# DEVELOPMENT REVIEW COMMITTEE (DRC) COMMENT REPORT

**PROJECT NAME:** YB Office

**CASE NUMBER:** PLN-SITE-20020004

**REQUEST:** Site Plan Level III Review: Parking Reduction request for 2,760 Square-Foot Office Building

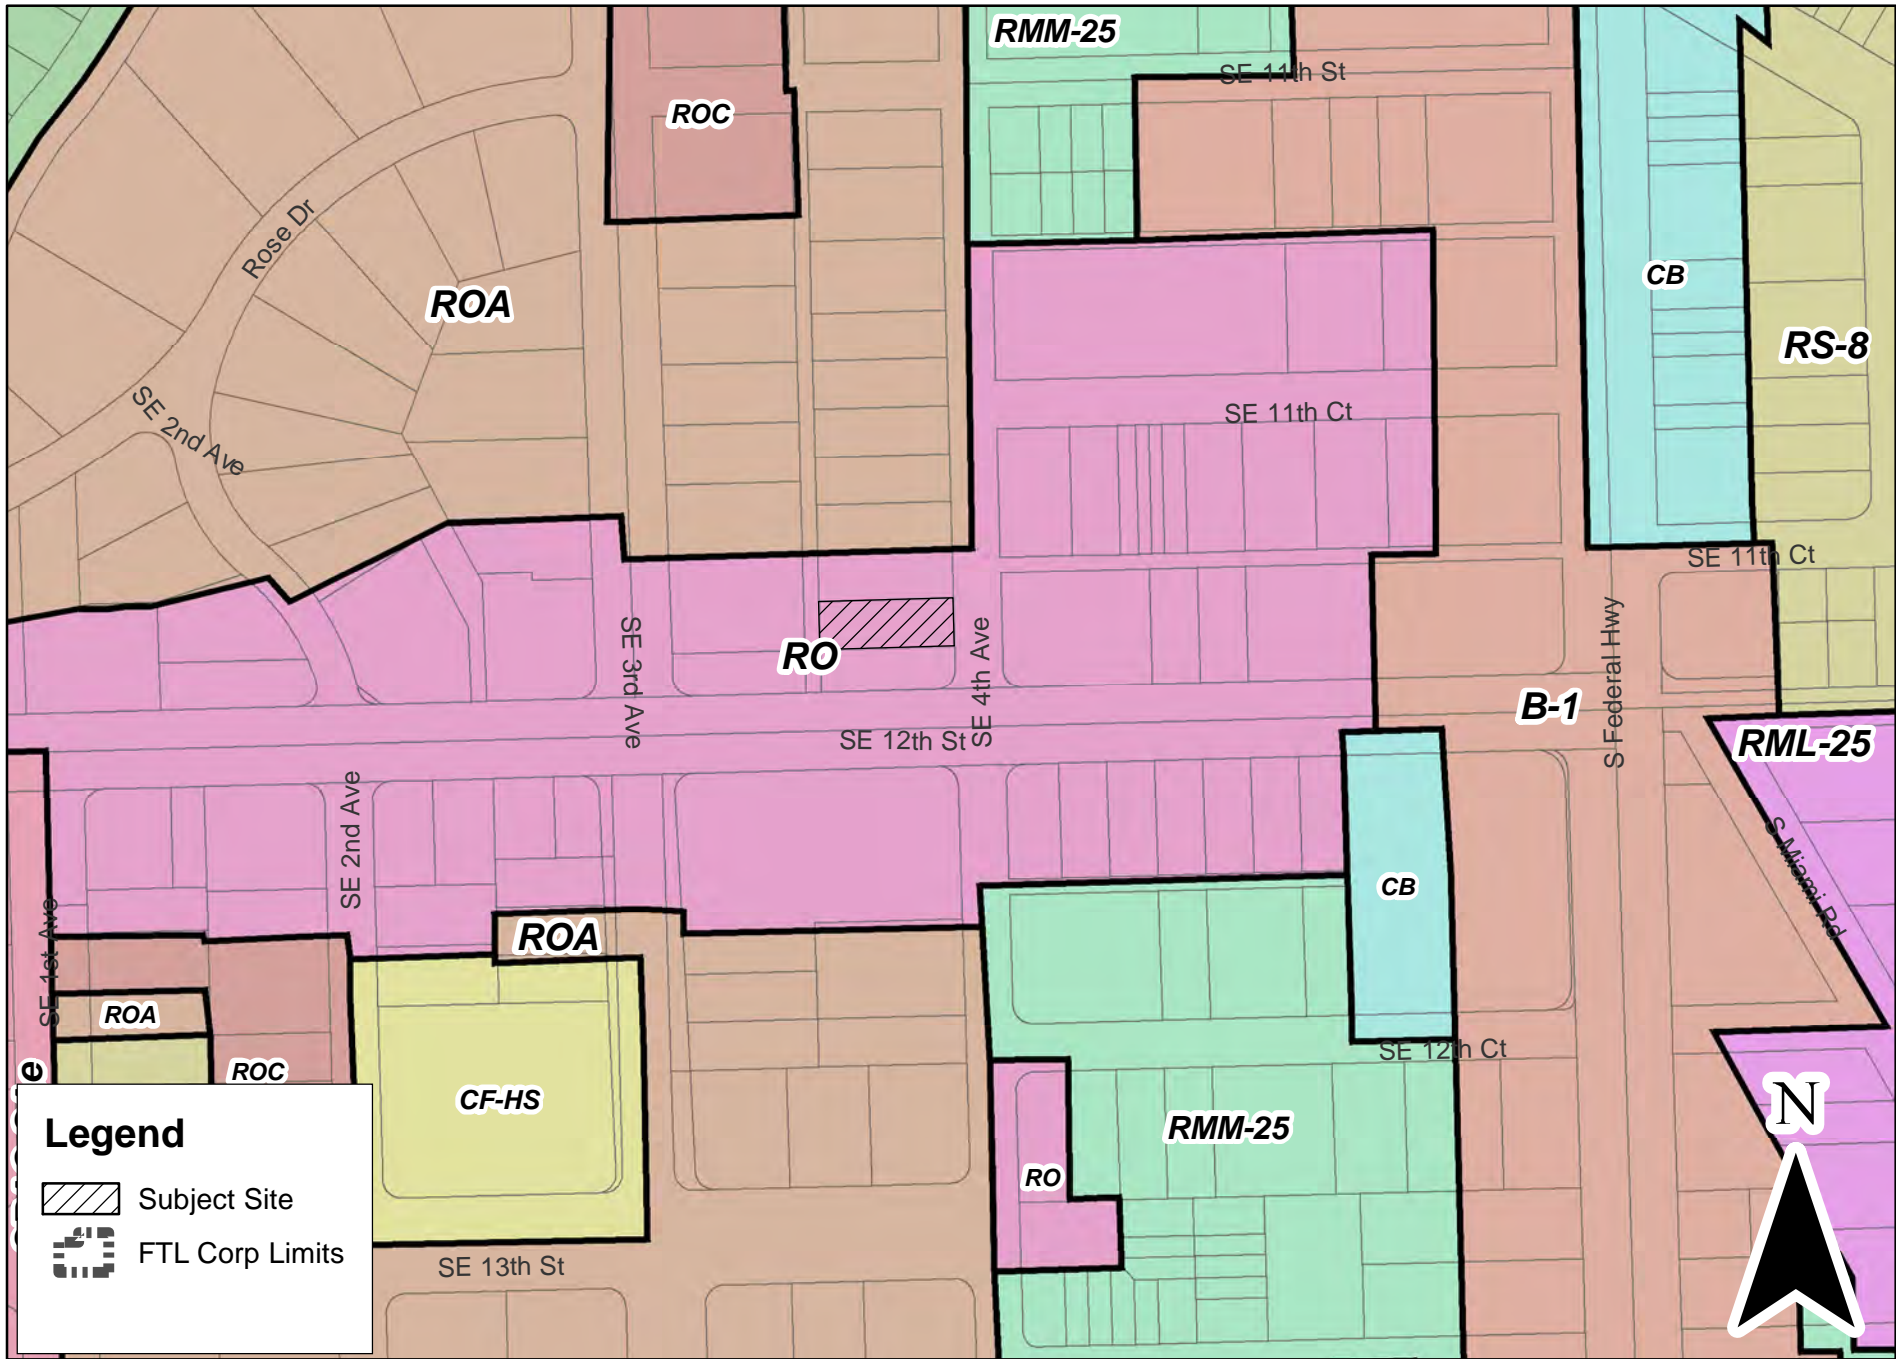
- a. If mechanical equipment is located on the roof, provide roof plan for all structures indicating the location of all mechanical equipment. This plan shall include spot elevations of the parapet wall and roof as well as mechanical equipment to verify adequate screening and to illustrate how equipment will be screened or shielded from view. Roof mounted structures such as air conditioners, compressors, generators, satellite dish antennae, and pool accessories shall be required to be

screened with material that matches the material used for the principal structure and shall be at least six (6) inches high above the top most surface of the roof mounted structure. In addition, indicate all mechanical equipment within the subject site on the site plan and elevations where applicable. Discuss the use of the roof as an accessible amenity.
